**Safety Evaluation Report
of
Homestake Mining Company of California
for the Large Tailings Pile Evapotranspiration
Cover Design
License Amendment Request**

December 2025

Materials License No. SUA-1471
Docket No. 040-08903

Figure 1: Proposed Final Cover System for the Top Slope of LTP (HMC, 2025b)

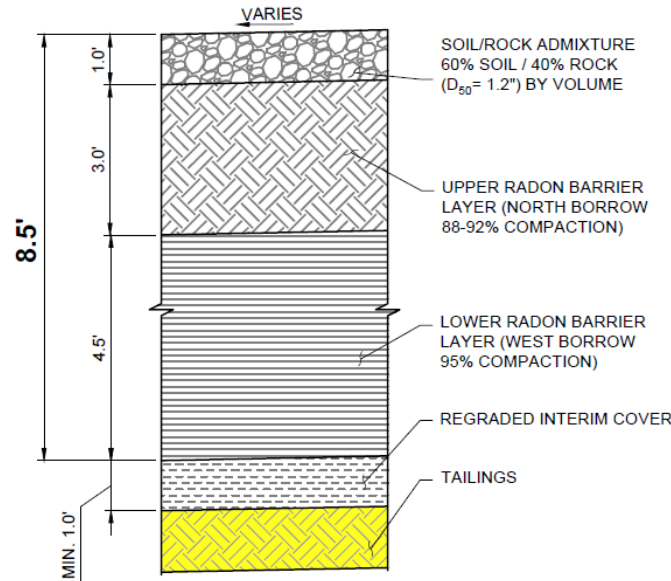
HMC presented the information on aspects of the design, investigation, and construction in Sections 3, 4, 5, 7, 8, 9, as well as Appendices G, H, and I. As shown in Figure 1 of this SER, HMC's proposed final cover system for the LTP top is an ET cover consisting of a rock/soil admixture (soil amended with rock with a D_{50} of approximately 1.2 inches present at 40 percent by volume). The rock/soil admixture is underlain by a 3-foot thick layer referred to as the upper radon barrier, which is intended to serve as a growth media layer. The lower radon barrier will have a thickness of 4.5 feet and lie beneath the growth media. The total remaining thickness of the final cover system to be installed is approximately 8.5 feet. Details 1 and 2 on Sheet C-8 show the cross section of the proposed final cover system and the tie-in with the existing cover system that was previously installed on the side slopes. As discussed in Section 3.1 of this SER, the NRC staff reviewed the borrow area characterization information. For the radon barrier, HMC plans to use soils identified as CL material (fine grained, low plasticity clay) under the Unified Soil Classification System. Use of this type of soil within the radon barrier is acceptable to the NRC staff. HMC considered potential biointrusion resulting from small animals in Section 6 and Appendix J.2 of the LAR.

The engineering drawings in Appendix I show the existing conditions, proposed grading plan, a cut/fill diagram, LTP cross sections, and a detail of the ET cover cross section. Detail number 1 on Sheet C-8 shows the proposed ET cover and side slope rock cover tie-in. Detail 1 on Sheet C-8, as well as Figure 2 of the LAR show a uniform thickness of the ET cover. The total

thickness of the cover is 8.5 feet. The NRC staff observed that the ET cover system does contain a low permeability layer, referred to as the lower radon barrier in HMC's design, that is designed to limit radon flux from underlying tailings. The NRC staff observed that HMC's design does not include a bedding layer and this approach is acceptable to the NRC staff, given that the erosion protection layer will consist of a rock/soil admixture at a ratio of 40 percent rock to 60 percent soil, measured by volume. The NRC staff reviewed the design drawings and determined that the thickness of the layers comprising the cover system is clearly identified and this is acceptable to the NRC staff.

HMC plans to construct a 4.5 feet thick lower radon barrier on top of the existing tailings. As shown on Figure 2 and Detail 2 on Sheet C-8 in the LAR, HMC's design includes a total soil depth of 4 feet above the radon barrier. In Appendix J.2 of the LAR, HMC discussed assumptions related to density of the radon barrier as a result of freeze/thaw effects. HMC accounted for changes in hydraulic conductivity in the upper radon barrier layer. The NRC staff agrees with HMC's statement that the frost penetration depth in the Grants area is approximately 20 inches. The NRC staff observed that the lower radon barrier is located beneath the frost penetration depth and this is acceptable to the NRC staff. Section 6.1 of this SER presents the NRC staff's evaluation of radon flux from the ET cover.
